Report: Review of Supplemental Draft Environmental Impact Statement (SDEIS) for the Proposed Stibnite Gold Project: Hydrologic- and Water-Related Impacts, Assumptions, Methodology and Approach

December 28, 2022

Figure 2-1. Meteoric Water Balance Sub-Basin Model Zones

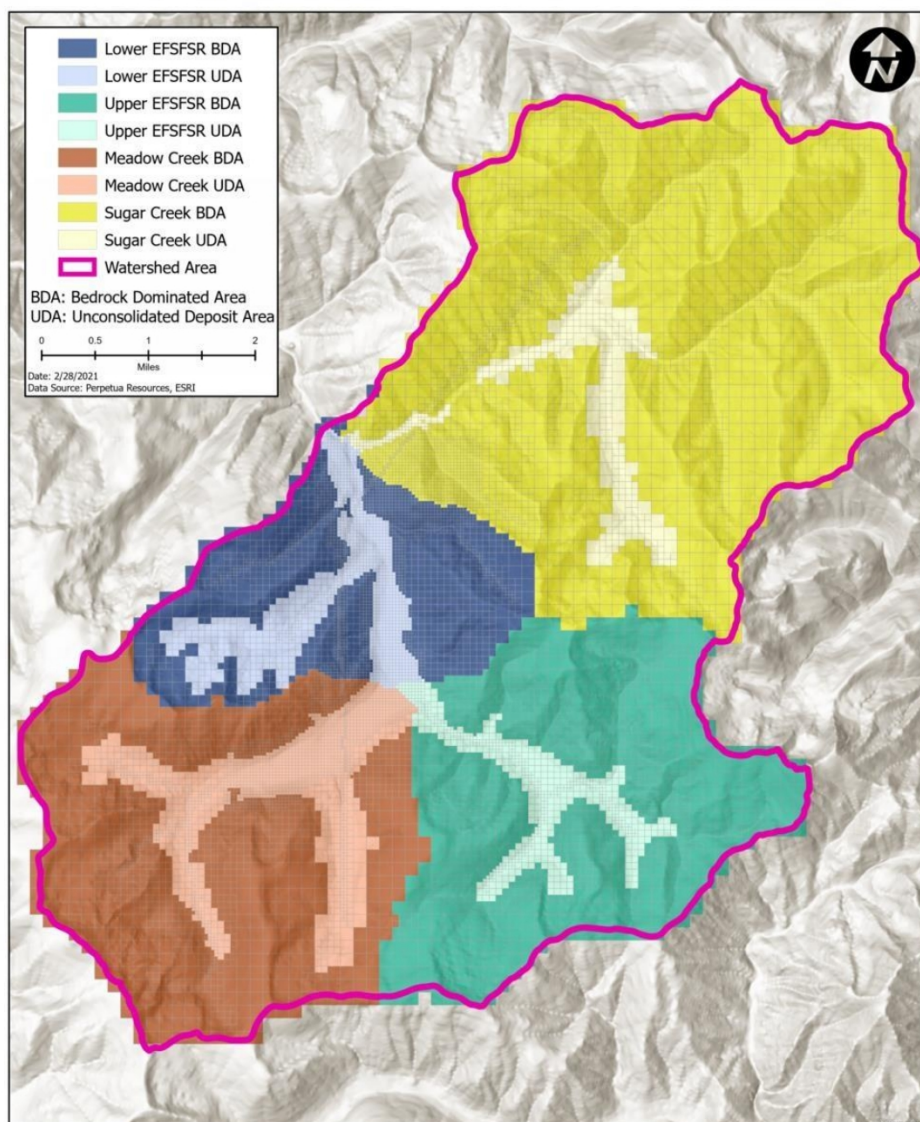
I.) It appears that the lumped approach adopted in development and application of MWB output (infiltration and runoff) to the Modflow 6 model utilized a simplification that across the entirety of each MWB model zone, corresponding to each of the eight individual colored areas in Figure 2-1 (reproduced below, from the 89th page in the flow modeling report (Brown and Caldwell, 2021a)), a uniform infiltration and recharge was supplied to the Modflow 6 model for each area. This highlights one aspect of lumping, spatial lumping, that was utilized in applying the MWB model to the SGP. The validity of this approach appears to be nowhere identified or referenced.

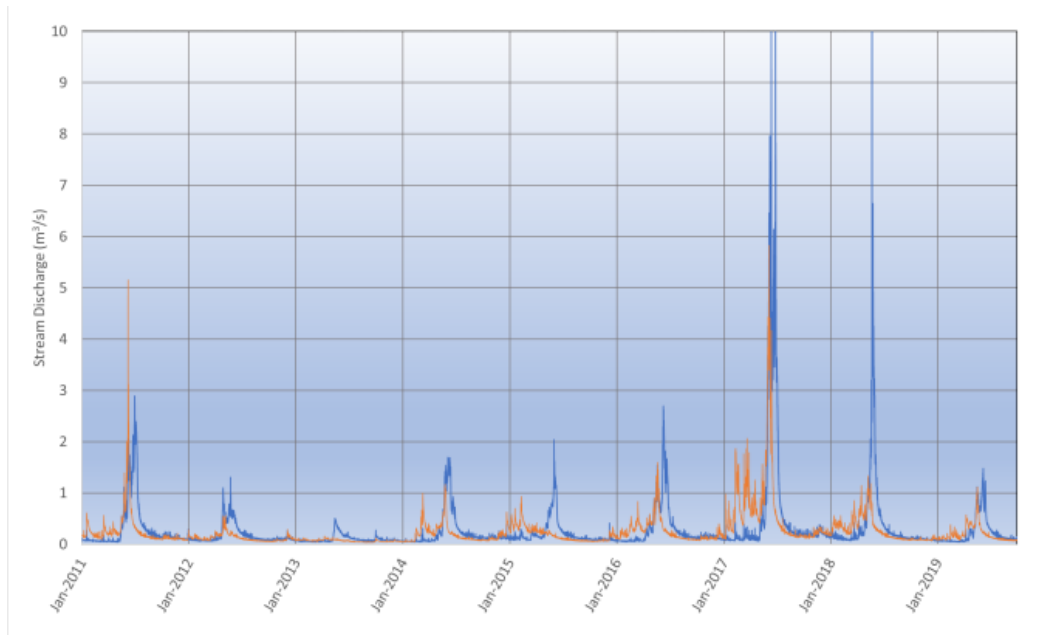
Climate data inputs informed by this type of information should have been but were not used in the 100-yr post-mining simulation and even for the 14-yr mine-period simulation. The implications of these Global Climate Model forecast changes on simulations of the hydrologic system include: higher evapotranspiration, diminished snowmelt, diminished runoff and diminished infiltration. Impacts of these sorts of forecast changes due to climate change, change that is in progress and occurring at an increasing rate, were simulated by Prucha (2020) for the SGP area using an integrated hydrological modeling approach that took advantage of Danish Hydraulic Institute (DHI) MIKE-SHE software. DHI software allows for integrated physical-process-based, conservation law abiding, surface water flow and groundwater flow simulation in a distributed rather than lumped-parameter fashion.

Two of Prucha's (2020) simulations over the 2011-2019 period, one for baseline climate as used by Perpetua (existing conditions – blue line) for discharge at the Meadow Creek USGS gage location, and one for based on the year 2100 climate change scenario (orange line), based on the SRA2 global climate model, for the same location are shown in the illustration below. The dramatic reductions in stream flow due to a significantly warmer climate are evident.

Figure 6-18. Additional Water Needs Boxplot

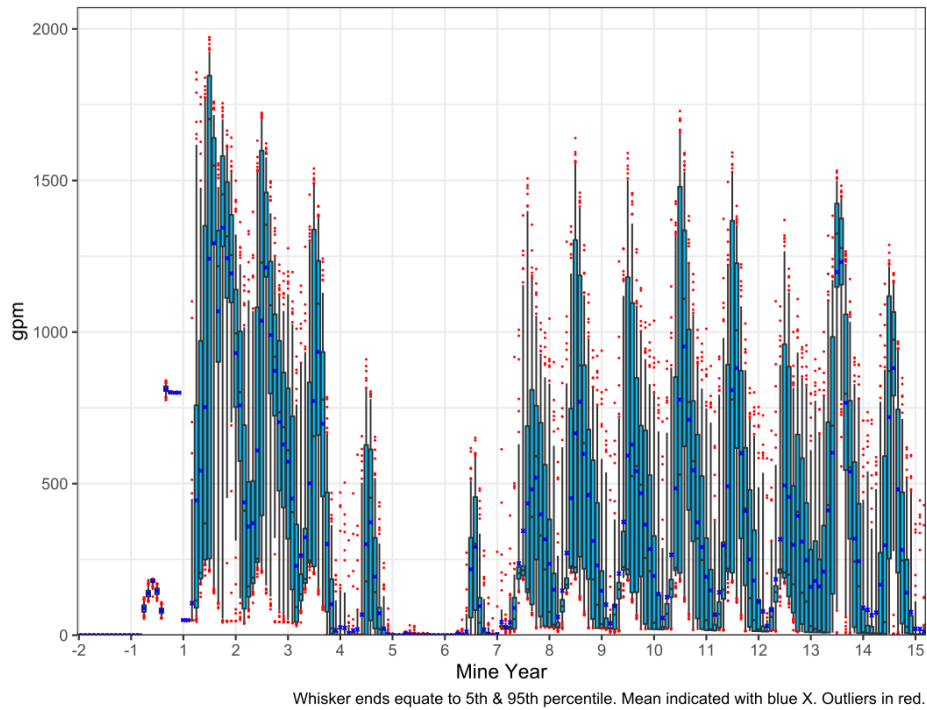
It appears that the terms “additional water” and “makeup water” may be interchangeable in the Brown and Caldwell (2021b) report, but perhaps not. Assuming that they are interchangeable, let’s look at the “additional” water, or “makeup” water needs on the project. Below is Brown and Caldwell’s (2021b) SWWB / GoldSim projection for additional water during the projected life of the mining operation. The first 2 years are for construction of the SGP; the remaining 14 years are the estimated life of the mining and ore processing operations.

Since the SWWB modeling basis for the makeup water volumetric flow rate is unknown, presumably because it is based on a proprietary model, and given the supporting documents' shielding of methodology, data, and parameters used in the SWWB / GoldSim model and modeling, the validity of estimating of the above-presented additional water requirements cannot be assessed.

Figure 6-19. Additional Water Needs from Groundwater Boxplot

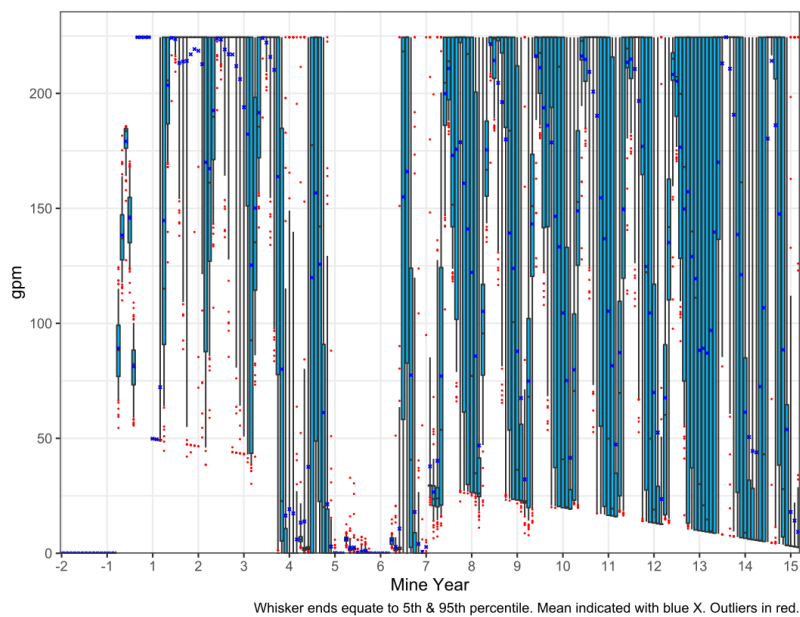
The breakdown of additional water needs as sourced from surface water as compared to that sourced from groundwater is shown in the next two plots, also from Brown and Caldwell (2021b)
